## **ADDENDUM NO. 1 - OUTLINE AND SUMMARY INFORMATION**

Project Name: Julia Martin Stairs PPA No.: 22-0656  
Location: Montana State University - Bozeman Date: 12/20/2023  
Owner: State of Montana, MSU - Bozeman  
Plew Building 6<sup>th</sup> and Grant, PO Box 172760  
Bozeman, Montana 59717-2760

**FOOTING & FOUNDATION PLAN @ BLD'G # 119**  
 SCALE 1/8" = 1'-0"

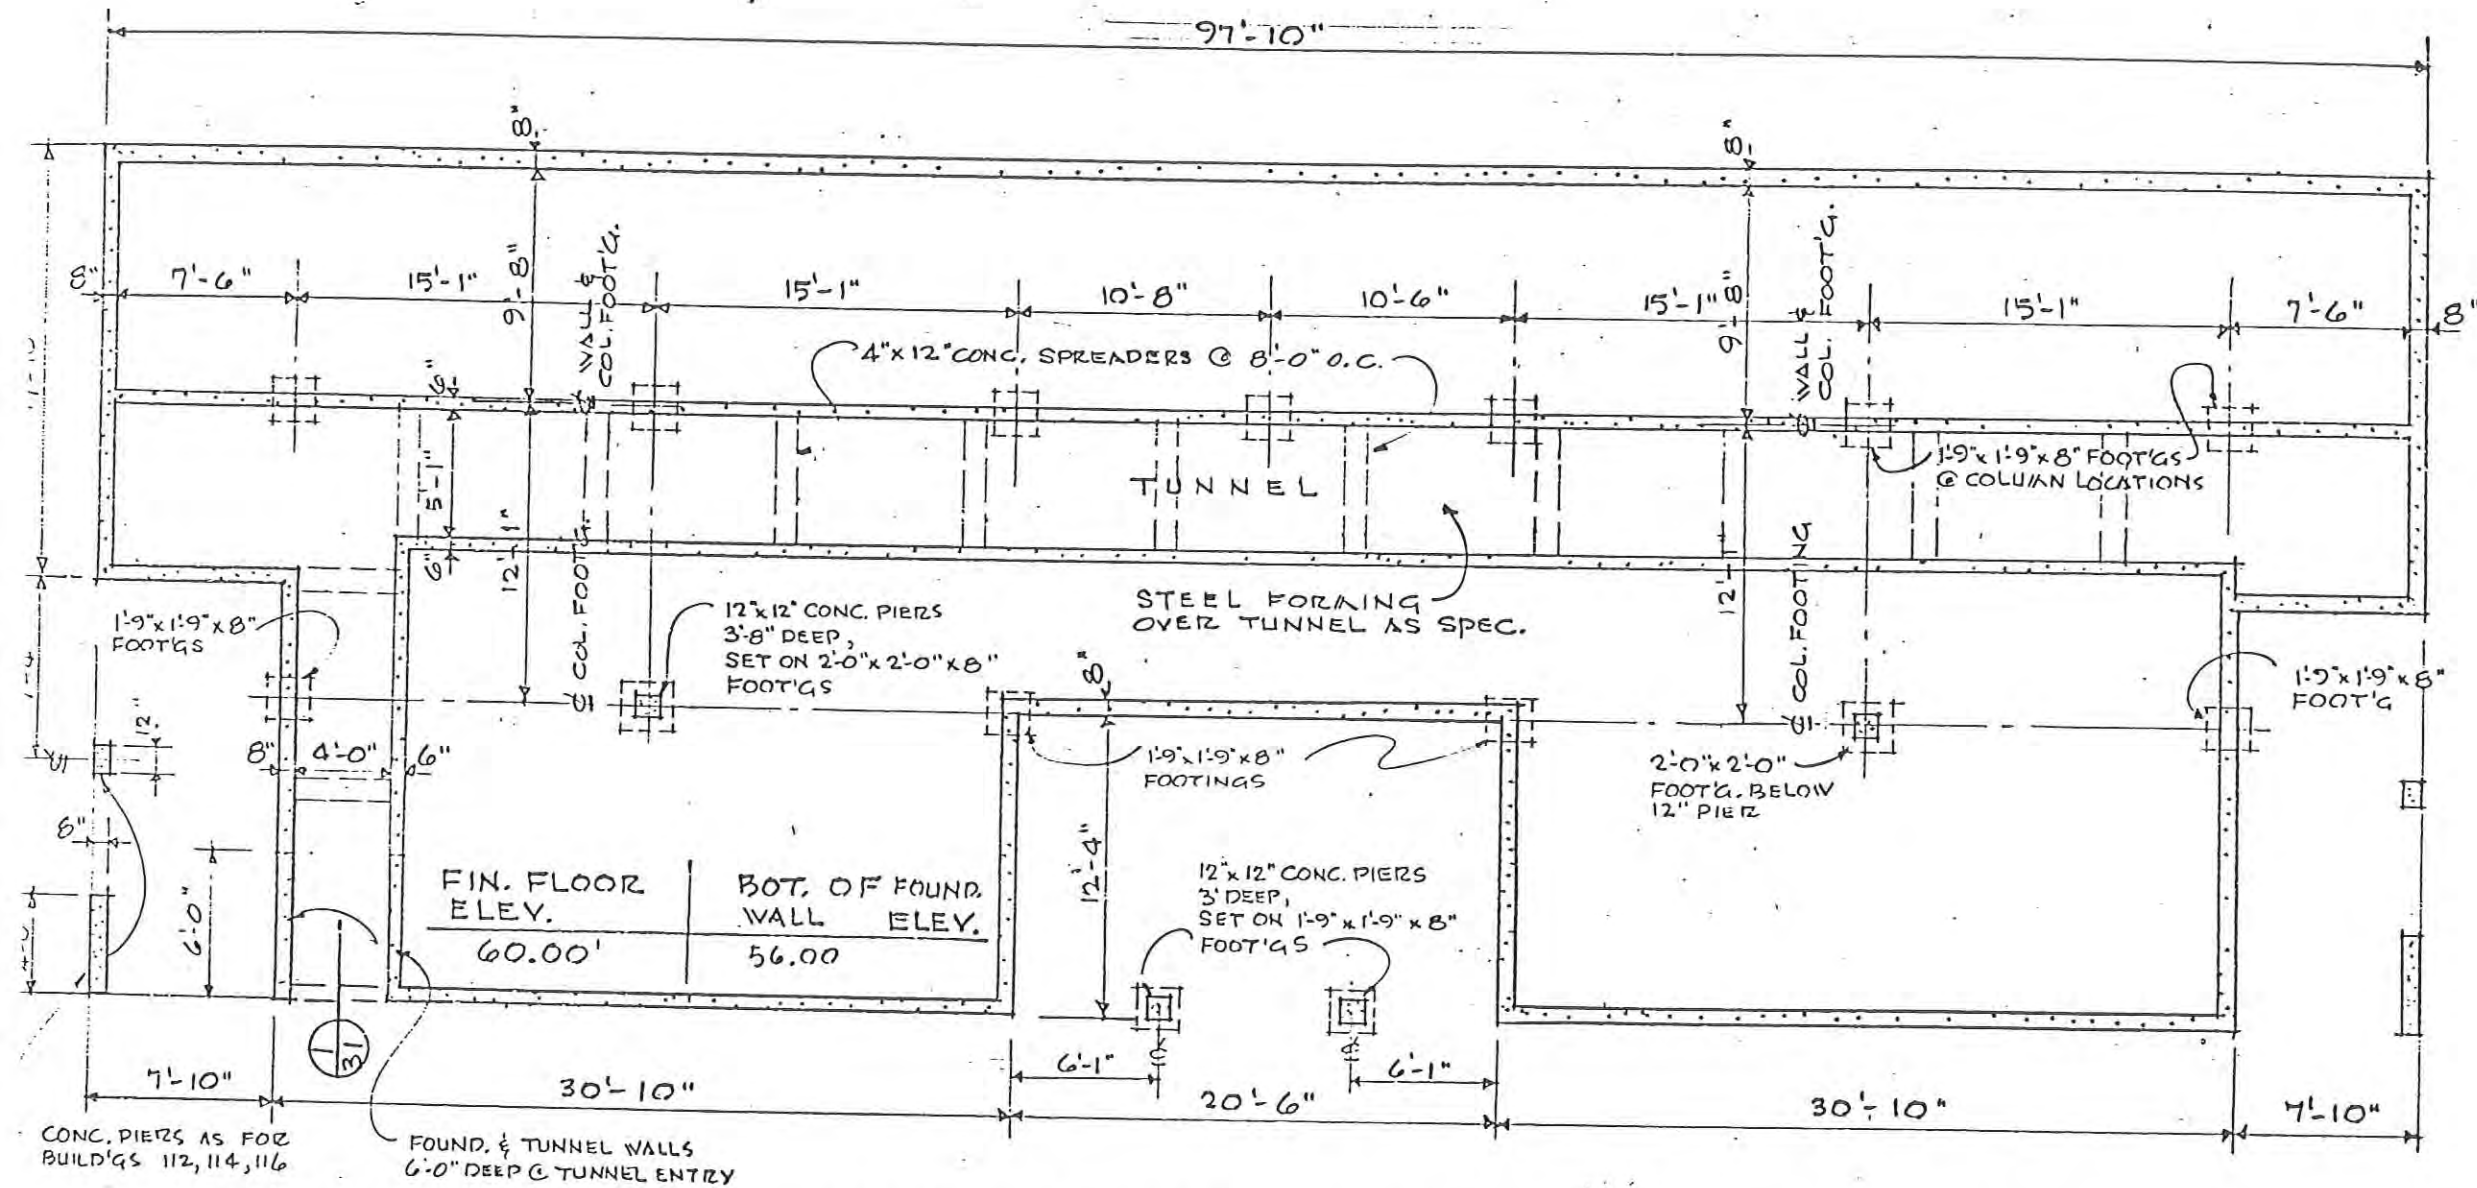
- xii. QUESTION: Are there as-builts/details of the existing slabs/foundations below the stairs?  
RESPONSE: We do not know if the plans we have are as-builts or construction drawings, but the foundation plans have been extracted and are attached as Exhibit 1. These are for reference only and are not to be considered as-built conditions.
